**LIMA TOWNSHIP PLANNING COMMISSION**  
**P.O. BOX 59, CHELSEA, MI 48118**  
**AGENDA**  
**MONDAY, MARCH 25, 2024 – 7:00 P.M.**

## **Site Plan Review For Lima Township, Michigan**

Re: St. Vladimir Russian Orthodox Church  
Preliminary Site Plan Review  
Plan Date: February 28, 2024

## Site Plan Review For Lima Township, Michigan

**Figure 1. Aerial Image of Subject Site and Vicinity**

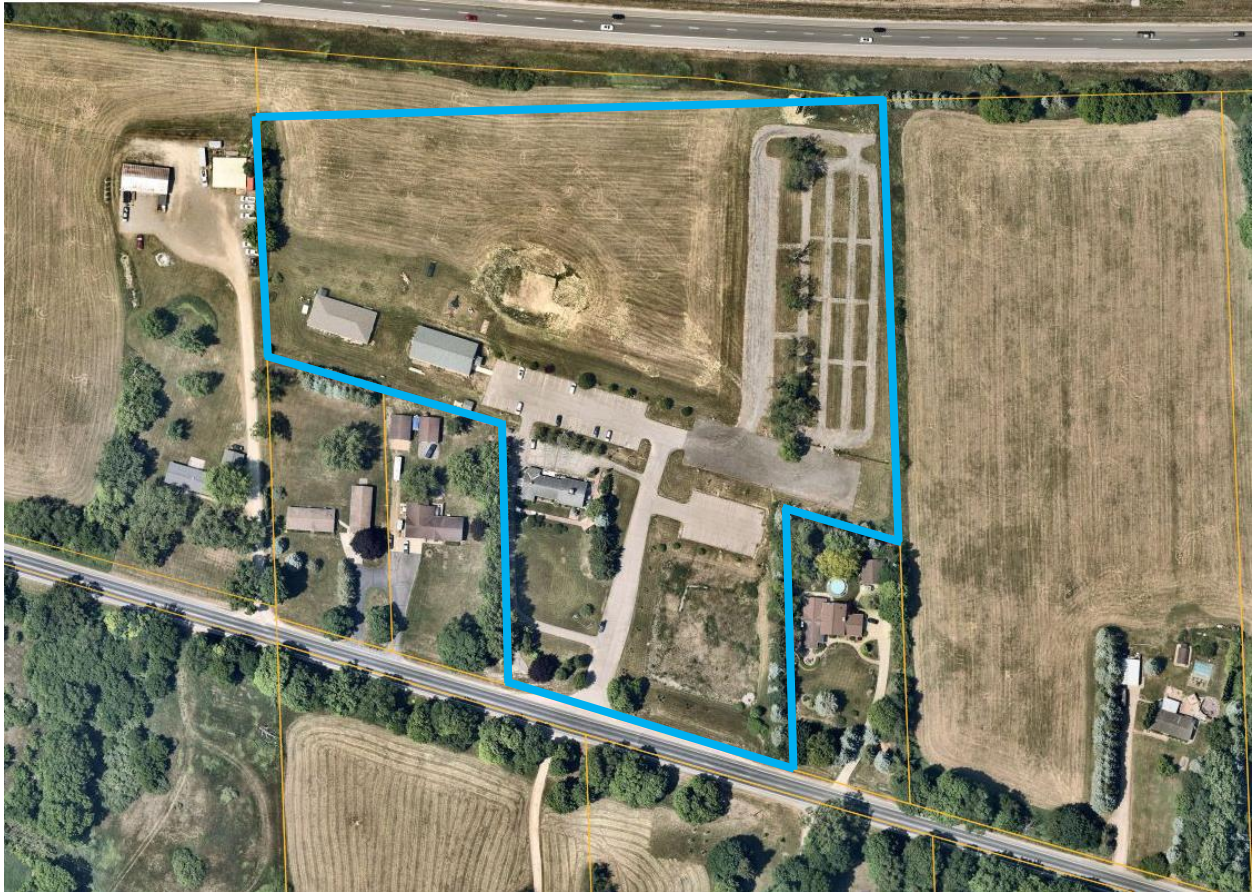
Details of Lot D which provided access to the cemetery are not provided. Aerial imagery shown in Figure 1 shows that this parking lot is unstriped.

**Figure 2. Barrier free spaces in Lot F.**

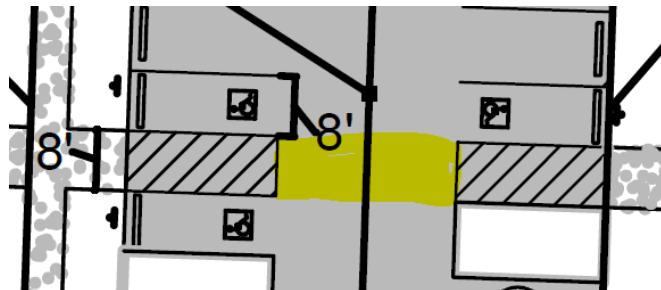
Five (5) total barrier free spaces are provided in the new Lot F parking area, creating eleven (11) total barrier free spaces on the site. There is one barrier free parking space on the east side of Lot F, but no crosswalk striping is provided across the drive aisle (see Figure 2).

**Items to be Addressed:** (1) The applicant shall adjust the parking lot dimensions to comply with the requirements in Section 11.5.6. (2) Applicant shall provide crosswalk striping across

*the drive aisle to provide clear pedestrian access to barrier free space. (3) Applicant shall provide parking details for Lot D.*

Fig. 1 Silt Fence Revision

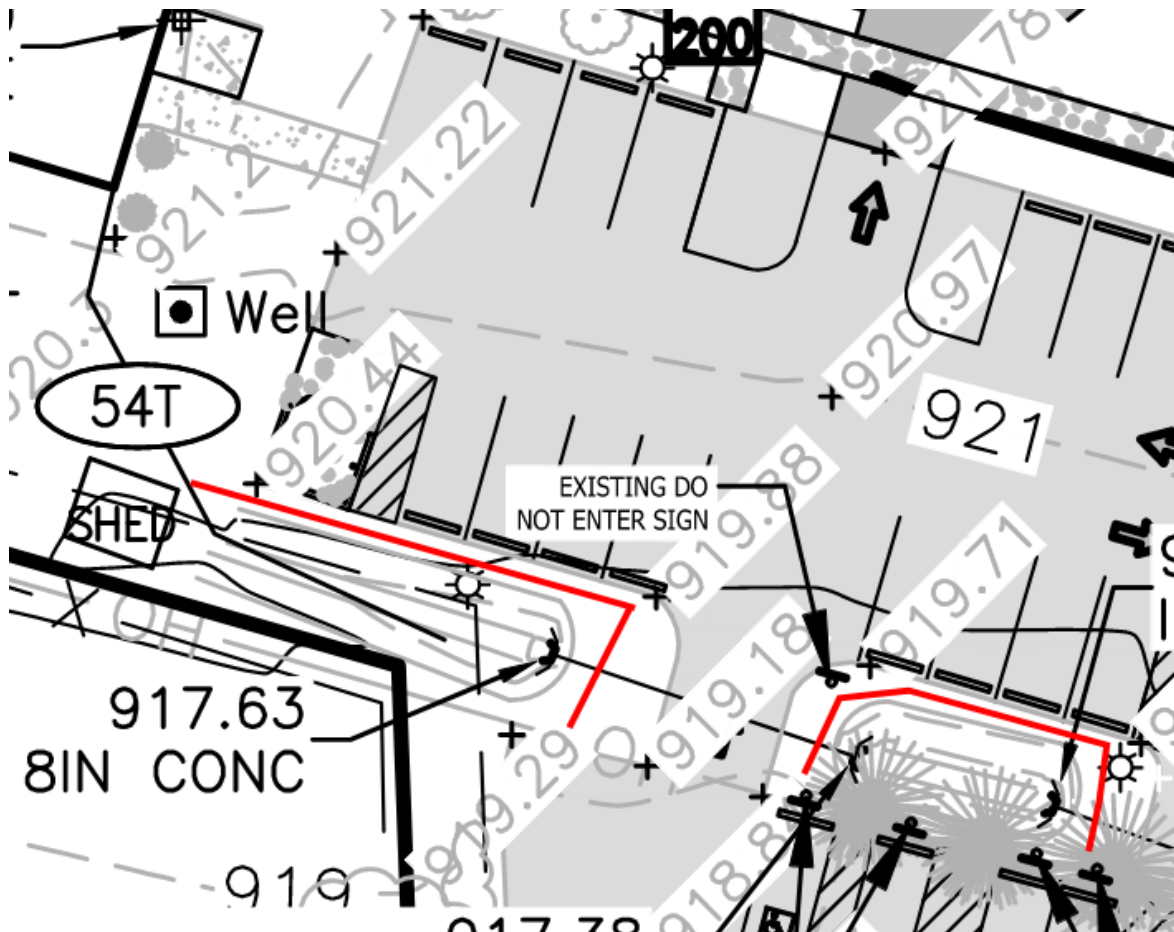
1. Silt fence should be brought to the top of the drainage swale to prevent from entering the detention basin during construction. See markup in figure below.

TITLE: **LANDSCAPE PLAN**

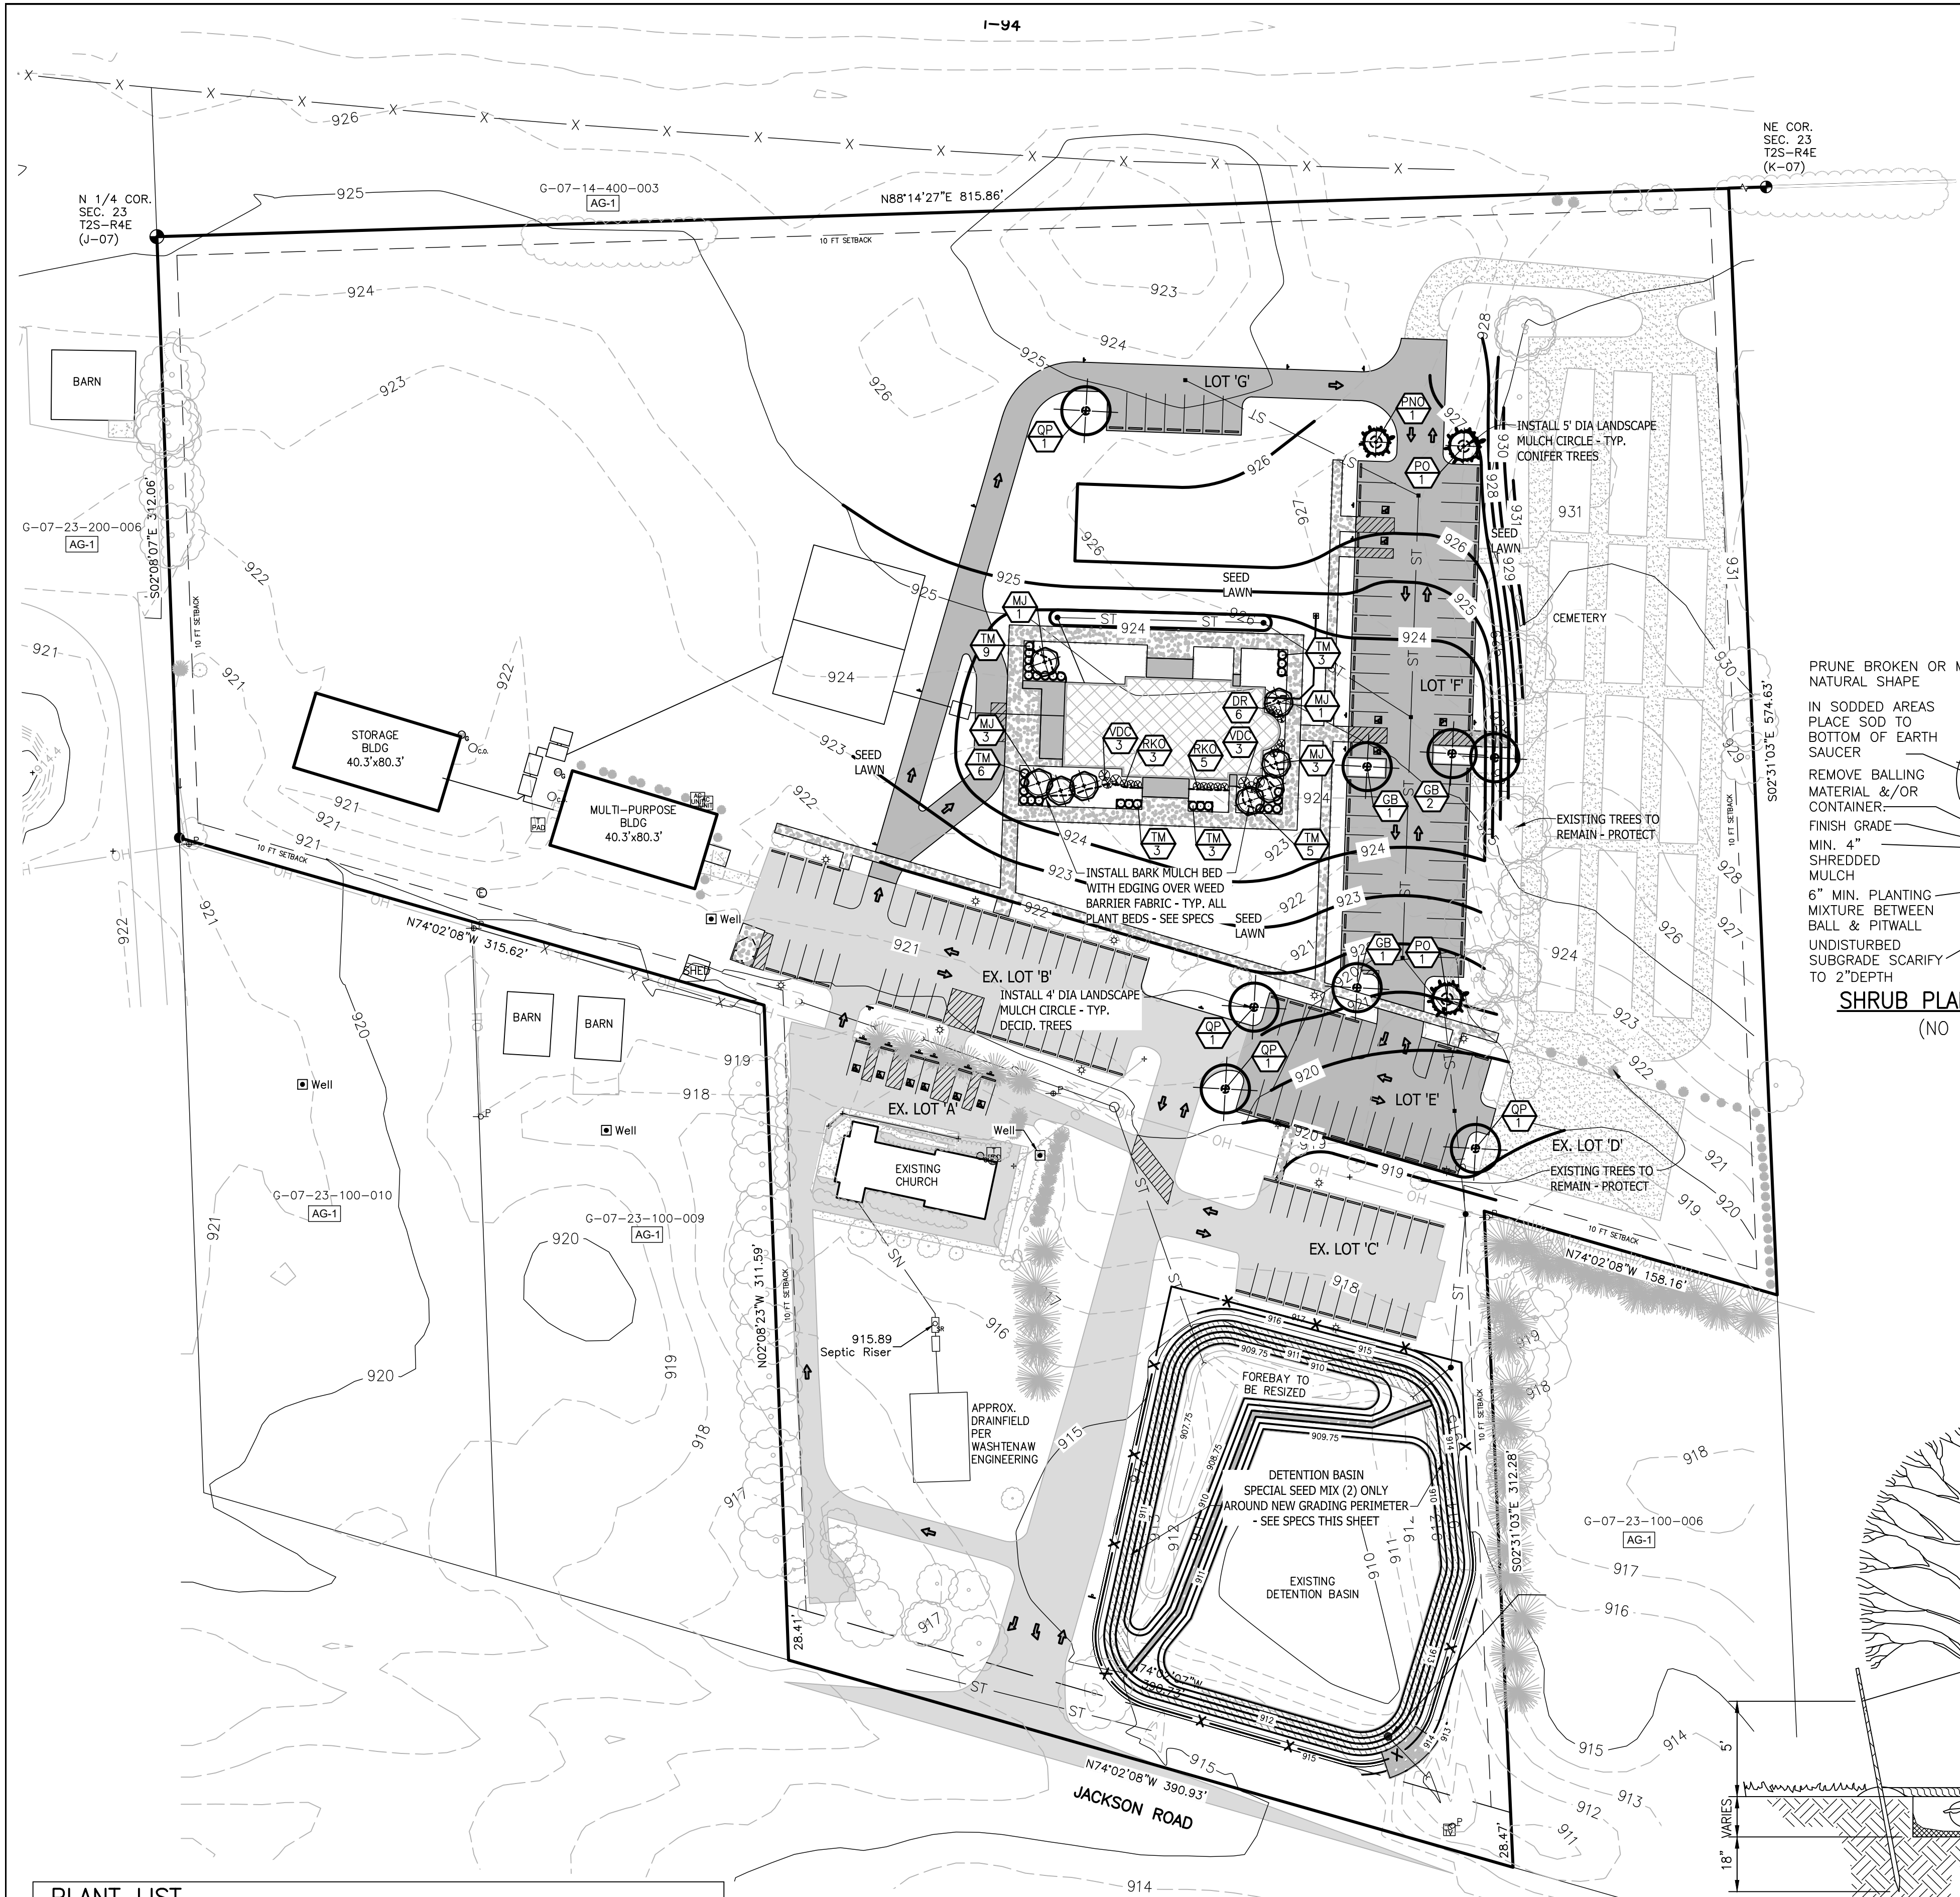
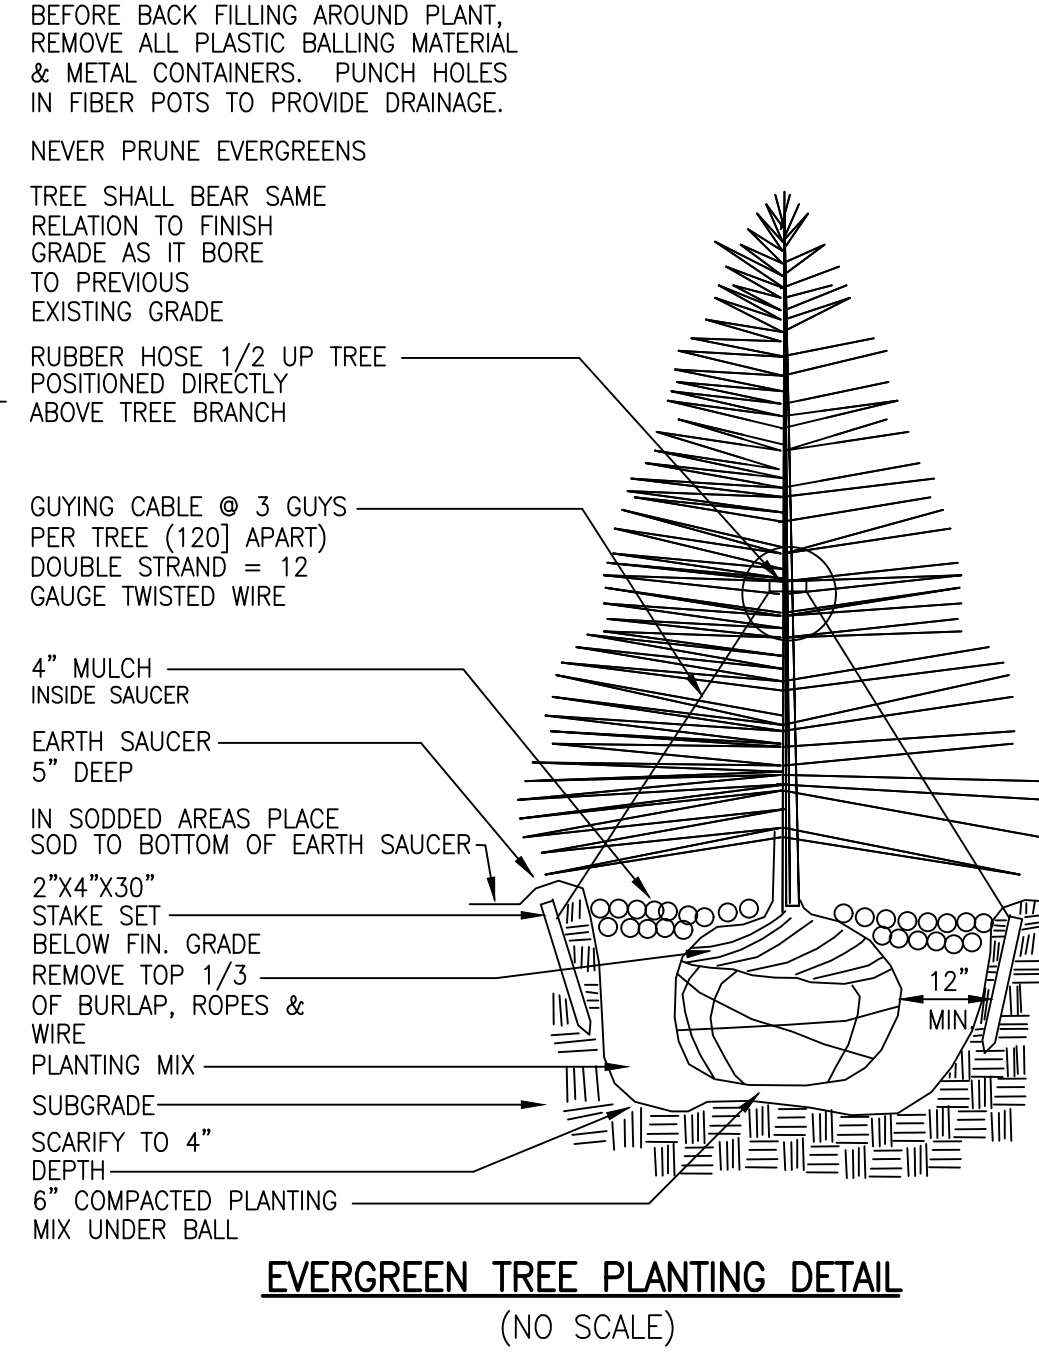
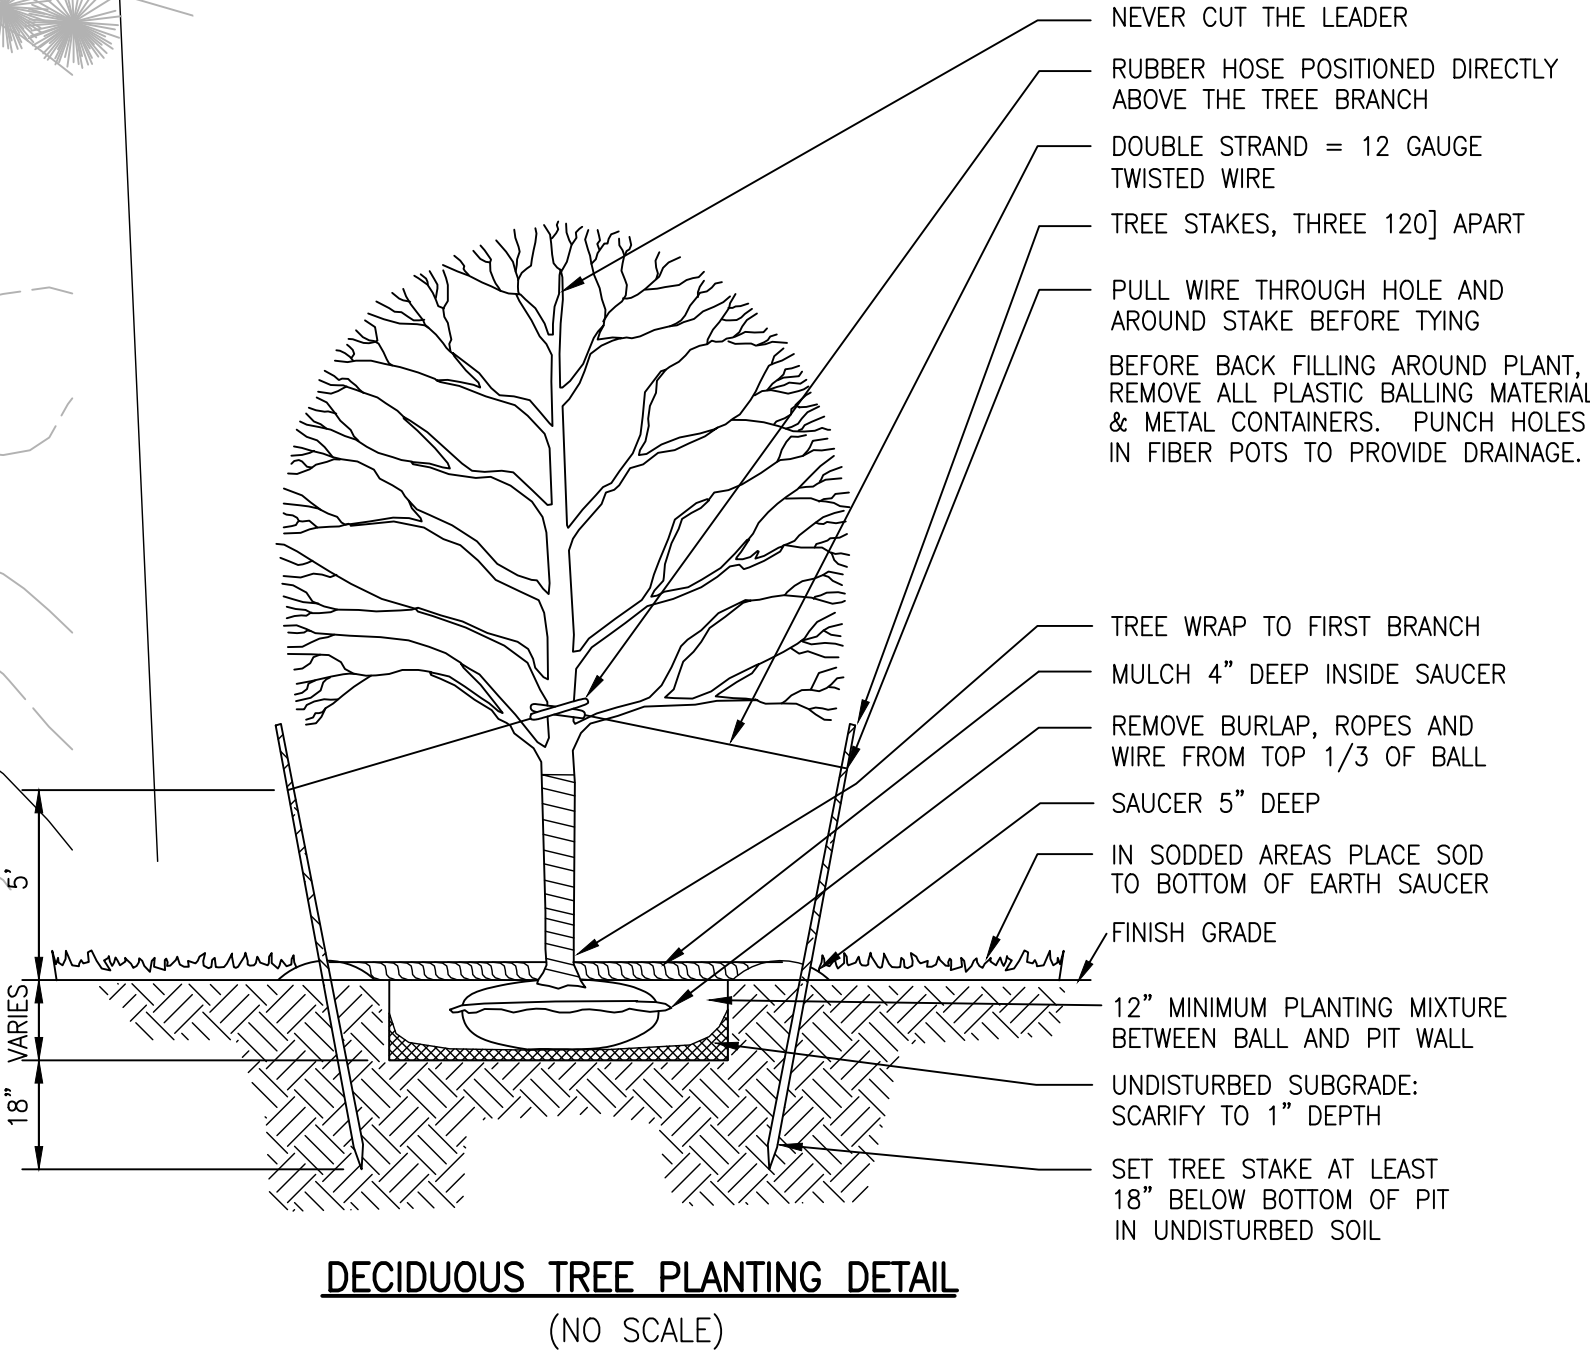
A landscape plan was included on Sheet 7, indicating the location and species of the proposed plantings. All the existing trees are proposed to remain. Table 4 details the landscaping requirements set forth in Section 6.2 of the zoning ordinance. Greenbelt landscaping is required along the road frontage; Sheet 7 indicates that the project is exempt from providing greenbelt landscaping, but no such exemption exists. Therefore, as detailed in Table 4, further landscaping along the road frontage is required.

Requirement	Provided	Compliance
<b>Greenbelt</b>	1 deciduous or evergreen tree + 6 shrubs every 30 feet in front yard setback	100+ feet with no trees	<b>Does not comply</b>
<b>Parking Lot</b>	1 tree for every 8 spaces, not including perimeter landscaping unless approved by Planning Commission  76 new spaces = 10 trees within the parking lot	2 Ginkgo trees provided in parking lot interior  9 additional trees located along parking lot perimeter	<b>Planning Commission may consider alternative parking lot landscaping</b>
<b>Screening between land uses</b>	6 ft vertical landscaping or wall between this parcel and adjacent residential parcels. 80% opacity	Partial screening (see Figures 3 and 4)	<b>Does not comply</b>
<b>General site landscaping</b>	In addition to any other requirements, 10% of site area must be landscaped	71% of the site is open space. 40 trees on site to be preserved. 8 trees and 49 shrubs provided around building	Complies

**Items to be Addressed:** (1) Applicant to amend site plan to provide sufficient greenbelt landscaping and screening between residential land uses. (2) The Planning Commission to consider perimeter parking lot landscaping instead of interior parking lot landscaping.
